**SUBDIVISION &
ZONING AMENDMENT STAFF REPORT****Date: June 1, 2017****APPLICANT NAME**

NAC Subdivision

LOCATION5803, 5809 and 5811 Old Shell Road
(Southwest corner of Old Shell Road and Long Street).**CITY COUNCIL
DISTRICT**

Subdivision Approval to create a single legal lot of record from a single legal lot of record and portions of two legal lots of record; and Rezoning from R-2, Two-Family Residence District, and B-2, Neighborhood Business District, to B-2, Neighborhood Business District, to eliminate split zoning. **It should be noted, however, that any use permitted in the proposed district would be allowed at this location if the zoning is changed. Furthermore, the Planning Commission may consider zoning classifications other than that sought by the applicant for this property.**

SITE PLAN

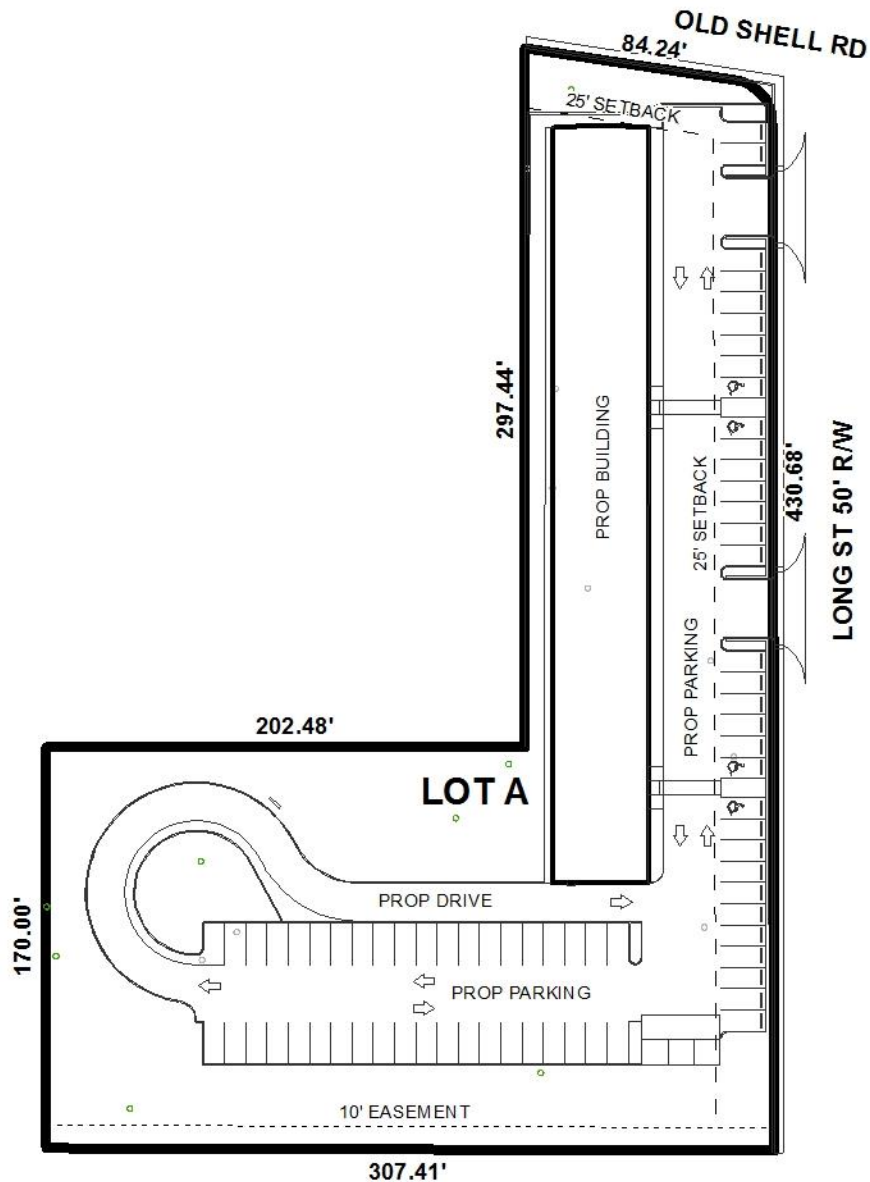
The preliminary plat illustrates the 25' minimum building setback along Old Shell Road and Long Street, but no setback is shown along the South property line, which abuts Waltman Lane. Because Waltman Lane is a private street incorporated into the abutting residential properties, and therefore zoned R-1, Single-Family Residential, there should be a 10' setback illustrated along Waltman Lane. If approved, this information should be illustrated on the Final Plat.

There is a 10' drainage and utility easement illustrated along the South property line, which abuts Waltman Lane, therefore, if approved, a note should be placed on the Final Plat stating that no structure should be erected in any easement.

Because the site is adjacent to residentially zoned property, a 6' high privacy fence is illustrated along the West and South property lines. It should be noted that the proposed fence to the South is proposed to be along Waltman Lane, and as such, should be relocated to be 10' minimum from the South property line. Additionally, the site plan states that a 10' buffer will be provided where adjacent to residential properties, but is not clearly depicted.

The site plan appears to illustrate proposed dumpsters on the site, but they are not labeled, and it appears they are partly located within the front 25' building setback along Long Street. If approved, the dumpster should be relocated to meet all setback requirements and be connected to sanitary sewer with a compliant enclosure.

The site plan does not provide tree planting or landscape area information, and it appears that with the proposed layout that the site would be severely short of required landscape area, and subsequently short on required tree plantings. It may be possible to redesign the layout in such a way to comply with the requirements. It should be noted that a condition of the previous rezoning approval was the granting of preservation status to a 68" live oak tree along Old Shell Road, which is illustrated as remaining on the site plan.

It appears that a drive thru is being proposed for one of the restaurant tenants. While queuing spaces are not specifically shown, it does appear that there are adequate queuing spaces available.

It appears that a sidewalk is illustrated along both Old Shell Road and Long Street, but is not labeled. A sidewalk will be required at the time of development along both public street frontages.
